PUBLIC HEARING MEMORANDUM

15 Riverdale Avenue

Subject: **Traffic Engineering Peer Review –
 Proposed Mixed-Use Development
 15 Riverdale Avenue
 Newton, Massachusetts**

Figure 1. Conceptual Improvements, California Street and Bridge Street Intersection

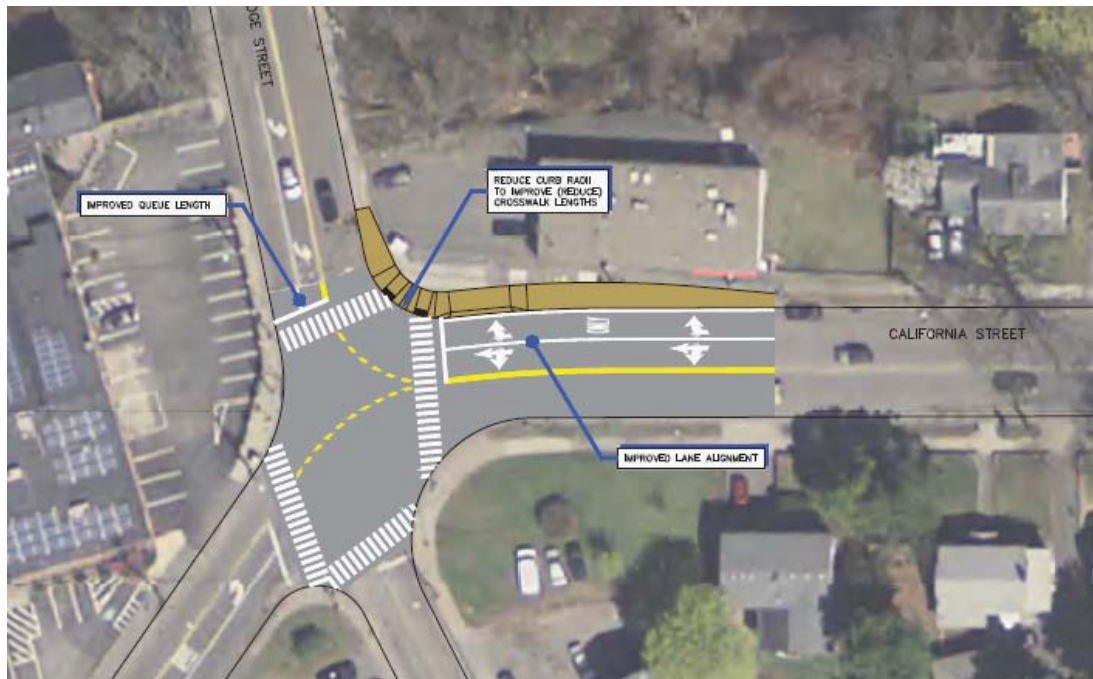
MDM states that the applicant is proposing to work with the City on a few pedestrian improvements to the intersection of California Street and Bridge Street and the intersection of California and Los Angeles Streets. Specifically, the applicant proposes a bump out at California and Bridge Streets to shorten crosswalks and better align the California Street westbound approach. As the intersection of California and Los Angeles Streets, the applicant proposes new Americans with Disabilities Act-compliant ramps, and a new pedestrian crossing with a rapid reflectorized flashing beacon (RRFB). The applicant is also proposing two pedestrian connections to the Forte Park. MDM also states that the applicant is continuing to work with abutters to install a sidewalk along the eastern portion of Los Angeles Street, staff suggests that the application provide an update on this improvement at the public hearing. The Planning Department will consult with the Transportation Division of Public Works regarding the improvements at the intersection of Bridge and California Streets, and well as the proposed RRFB at the intersection of California and Los Angeles Streets.

20. The proposed wheelchair ramp shown in Figure 11 in the March 2020 TIA, at the northeast corner for the California Ave / Bridge Street intersection adjacent to the driveway entrance appears to have

a ramp transition length immediately next to the transition piece for the driveway entrance. Please review this location further to see if it is possible to provide level walking areas between ramps for providing ADA-accessible facilities. In the event that the ramp remains flush with the driveway, a barrier should be provided, similar to existing conditions, to prevent vehicles from exiting the property through the ramp.
